**Attachment F – Photo-Simulations, Geographic
Service Area Map and Alternative Site Analysis**

DEER SPRINGS CROWN CASTLE WIRELESS TELECOMMUNICATION FACILITY
SCOPING LETTER
 RECORD ID: PDS2018-ZAP-99-023W1; PROJECT ADDRESS: 2691 MESA ROCK ROAD,
 ESCONDIDO, CA 92025; APN: 186-611-20

ITEM 13-1—13-3: Alternative Site Analysis

Figure 1

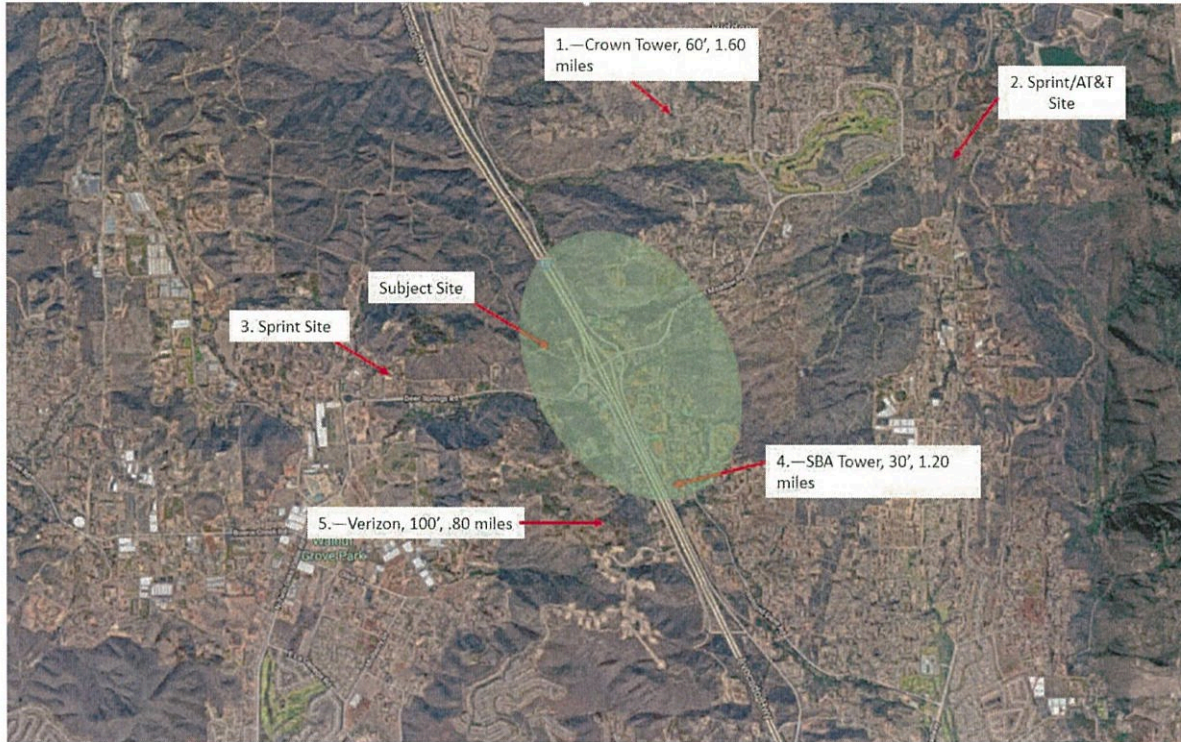
Item 13-1—Coverage Justification: this AT&T site provides coverage along the I-15 corridor and Deer Springs Road intersection, which is a high-traffic area (q.v., Figure 1, green shading). To lose this site, AT&T would have a significant drop in coverage along both this portion of I-15 and the Deer Springs on-/off-ramps. For AT&T customers, they would experience a high volume of dropped calls, as the carrier signal would not have a site to hand off the call from adjacent sites in all directions.

Item 13-2—Nearby Sites: following are the closest sites to the subject site, and the reason why they are non-viable for a collocation for AT&T and Sprint, the two carriers located on this tower. Figure 1 illustrates the approximate location of these nearest sites.

1. **Crown Tower**—too far away at 1.60 miles, to provide the coverage footprint that AT&T and Sprint are covering here (the intersection of Deer Springs and I-15 north- and south-bound. The signals would also experience physical interference from the topography and foliage in the area.

2. **Sprint/T-Mobile Collocation**—both carriers have a site here, which provides coverage to the residents in the northeastern part of Escondido, and interconnects with the subject site. It is too far away at 1.20 miles to meet the coverage objective, given the topography and landscape.

3. **Sprint Site**—Sprint has an existing site at this location, providing coverage along the Deer Springs interior, and interconnects to the Sprint site at the subject location. Topography and landscape (mature trees) prevent this location from covering the Deer Springs/I-15 intersection.

4. **SBA Tower**—too far south (1.2 miles) to interconnect with the nearby Sprint/AT&T sites respectively, and would not cover the Deer Springs/I-15 intersection.

5. **Verizon Site**—too far away at .80 miles, given the hilly terrain/topography, and the tower is loaded with panel antennas and microwave dishes; there is no space on the existing tower. Regardless, the centerline for the antennas would be far too low and the distance too great to propagate to the coverage objective.

Figure 1

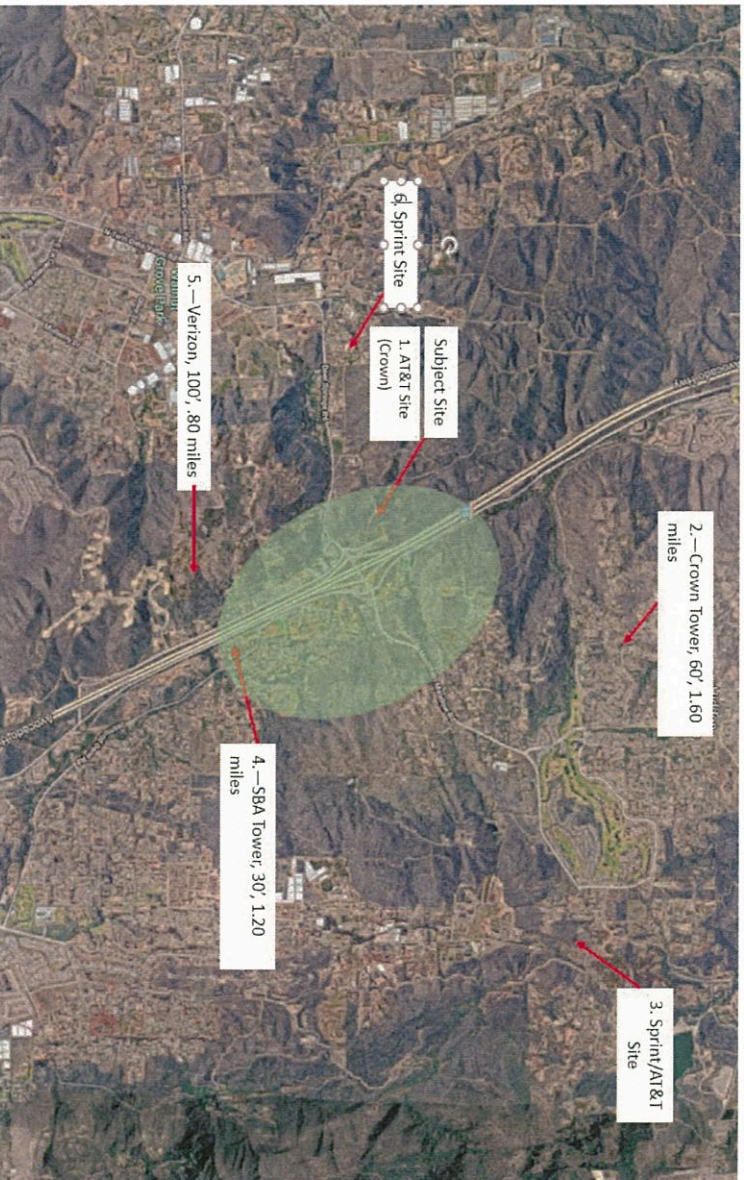
Item 13-1—Coverage Justification: this AT&T site provides coverage along the I-15 corridor and Deer Springs Road intersection, which is a high-traffic area (q.v., Figure 1, green shading). To lose this site, AT&T would have a significant drop in coverage along both this portion of I-15 and the Deer Springs on-/off-ramps. For AT&T customers, they would experience a high volume of dropped calls, as the carrier signal would not have a site to hand off the call from adjacent sites in all directions.

Item 13-2—Nearby Sites: following are the closest sites to the subject site, and the reason why they are non-viable for a collocation for AT&T and Sprint, the two carriers located on this tower. Figure 1 illustrates the approximate location of these nearest sites.

1. **AT&T (Crown Tower)**—near the subject site, this 30' high monopole is of insufficient height for additional carriers to locate. AT&T requires 10'-15' separation from its competition (to avoid RF interference), which would put a second carrier at a centerline of approximately 15', and a third carrier would be impossible.

To combine both towers into one taller tower that could support 3 carriers would require an overall tower height of 80' or more, given the coverage objectives of all 3 carriers and their need for the existing respective centerlines and need to interconnect with neighboring sites. This would create a starker visual impact to the area than the existing two towers. In addition, this second tower is within a specific Crown portfolio for which there are convoluted rights involving multiple parties not controlled by Crown. Finally, the underlying landlord has plans to develop these parcels and is not willing to give up additional land to accommodate a new tower.

2. **Crown Tower**—too far away at 1.60 miles, to provide the coverage footprint that AT&T and Sprint are covering here (the intersection of Deer Springs and I-15 north- and south-bound. The signals would also experience physical interference from the topography and foliage in the area.
3. **Sprint/AT&T**—both carriers have a site here, which provides coverage to the residents in the northeastern part of Escondido, and interconnects with the subject site. It is too far away at 1.20 miles to meet the coverage objective, given the topography and landscape.
4. **SBA Tower**—too far south (1.2 miles) to interconnect with the nearby Sprint/AT&T sites respectively, and would not cover the Deer Springs/I-15 intersection.

5. **Verizon Site**—too far away at .80 miles, given the hilly terrain/topography, and the tower is loaded with panel antennas and microwave dishes; there is no space on the existing tower. Regardless, the centerline for the antennas would be far too low and the distance too great to propagate to the coverage objective.
6. **Sprint Site**—Sprint has an existing site at this location, providing coverage along the Deer Springs interior, and interconnects to the Sprint site at the subject location. Topography and landscape (mature trees) prevent this location from covering the Deer Springs/I-15 intersection.
